Agenda Item # 15

SUB-003209-2025 & ZON-UDC-003210-2025

The Knollwood Place, First Addition

APPLICATION NUMBER	15	DATE	February 20, 2025
APPLICANT	The Knollwood Place, First Addition		
REQUEST	Subdivision, Rezoning from R-1 and B-1 to R-3

SITE PLAN

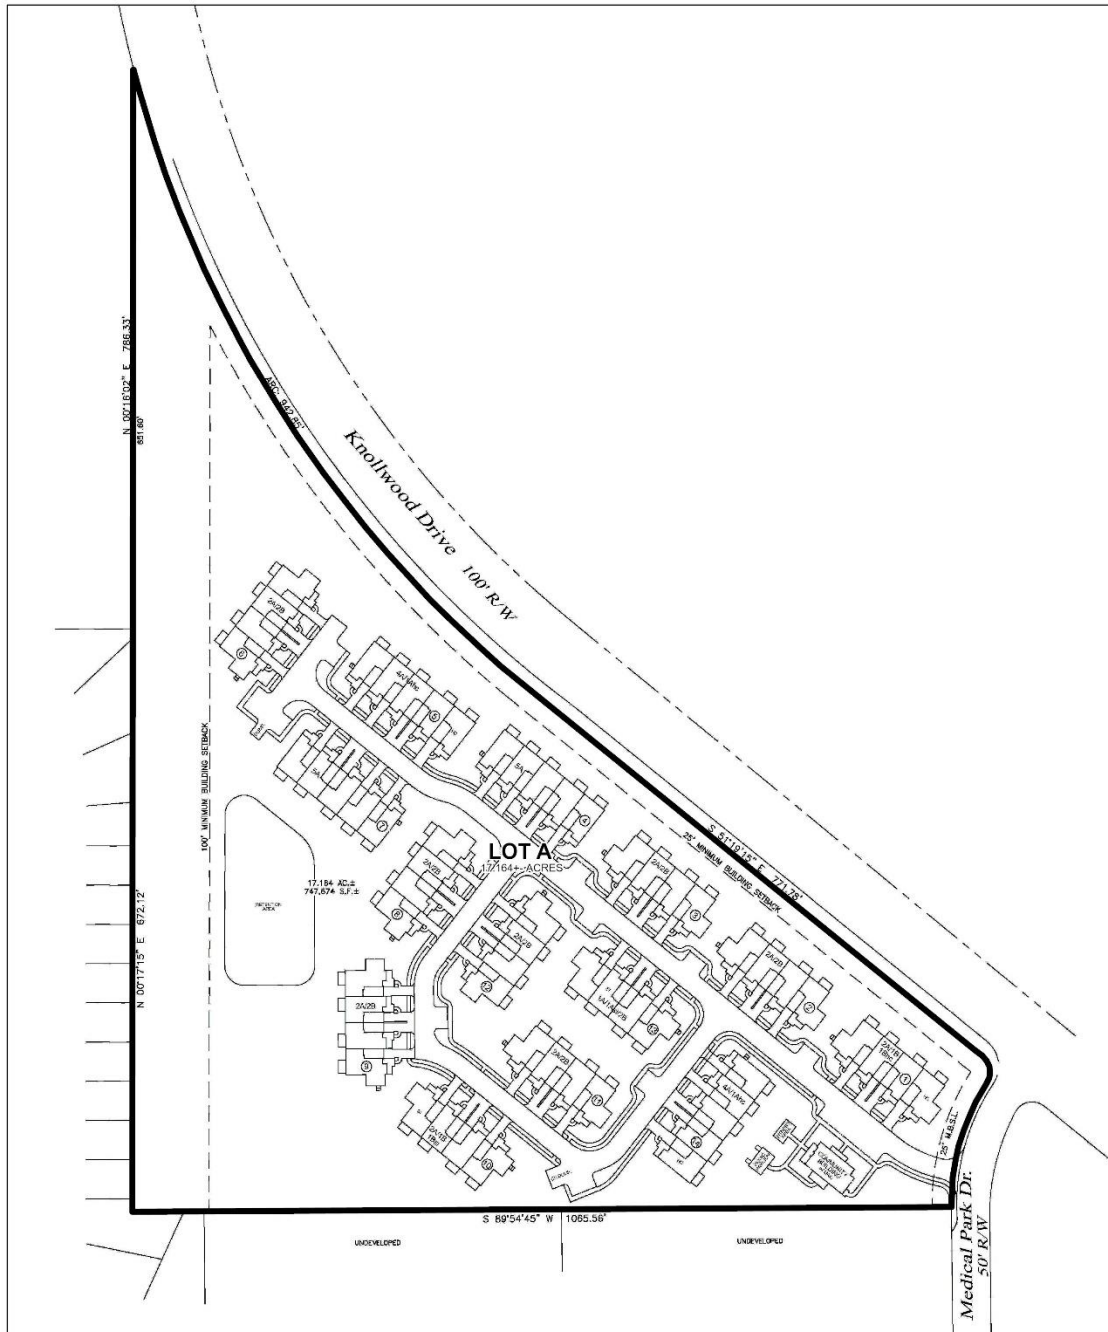
The site plan submitted with the rezoning application conceptualizes the construction of an apartment complex dedicated to housing elderly people, a use permitted by right in an R-3 Suburban district. The property is currently undeveloped, therefore, if approved, full compliance with the development standards of the UDC will be required and must be illustrated on all site plans submitted for review with the associated development permits.

DETAIL SITE PLAN

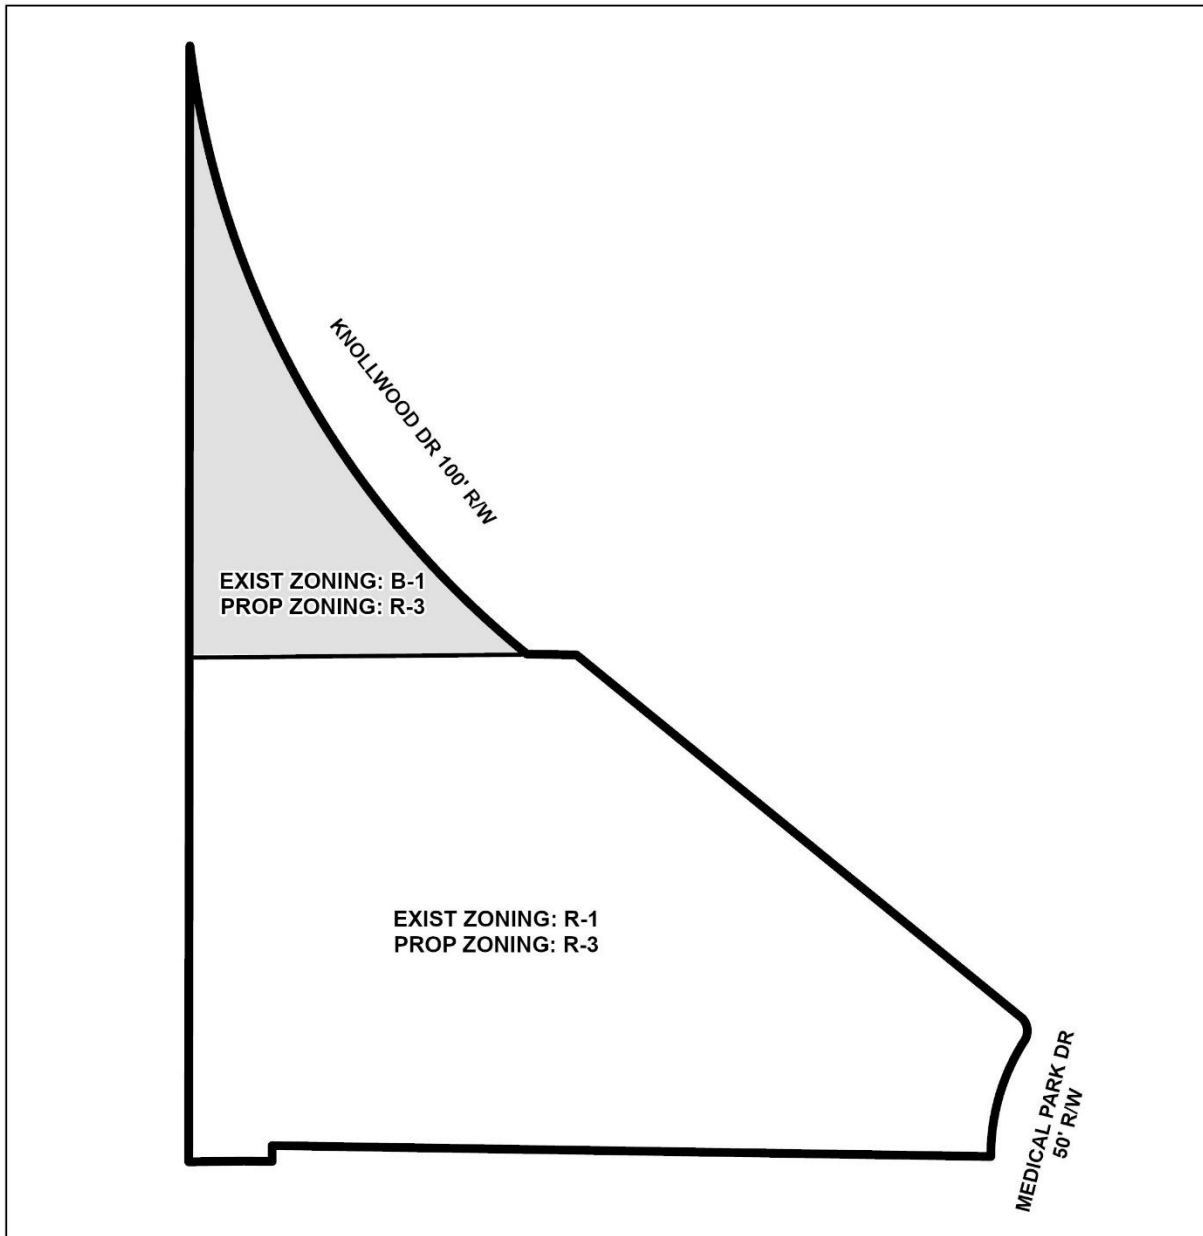
The site has frontage along Knollwood Drive, a major collector street requiring a 100-foot-wide right-of-way, and Medical Park Drive, a minor street with curb and gutter requiring a 50-foot-wide right-of-way. The plat depicts a sufficient right-of-way widths along both streets, making additional dedication unnecessary.

A 25-foot corner radius at the intersection of Knollwood Drive and Medical Park Drive was dedicated with the recording of the most recent subdivision and should be retained on the Final Plat, if approved.

A 25-foot front yard setback is illustrated along Knollwood Drive and Medical Park Drive on the preliminary plat, in compliance with Section 5.C.2.(i) of the Subdivision Regulations, and Article 2, Section 64-2-7.E. of the Unified

A 100-foot setback is illustrated where the site adjoins a single-family residential subdivision, to the West. This exceeds the applicable setback and protection buffer requirements of the UDC for lots in any zoning district. While side yard setbacks are not required to be depicted on a subdivision plat, provision of such a large setback may be acceptable to the property owner and the surrounding neighborhood to prevent development within at least 100 feet of the adjoining subdivision; however, the side yard setback may be removed from the plat prior to its recording in Probate Court.

1. Retention of the right-of-way widths of Knollwood Drive (100 feet) and Medical Park Drive (50 feet) on the Final Plat;
2. Retention of the 25-foot corner radius at the intersection of Knollwood Drive and Medical Park Drive;
3. Retention of the 25-foot minimum building setback line along both street frontages;
4. Retention of the lot size label in both square feet and acres on the Final Plat, or the furnishing of a table on the Final Plat providing the same information;
5. Completion of the Rezoning process to eliminate the potential for split-zoning prior to signing the Final Plat;
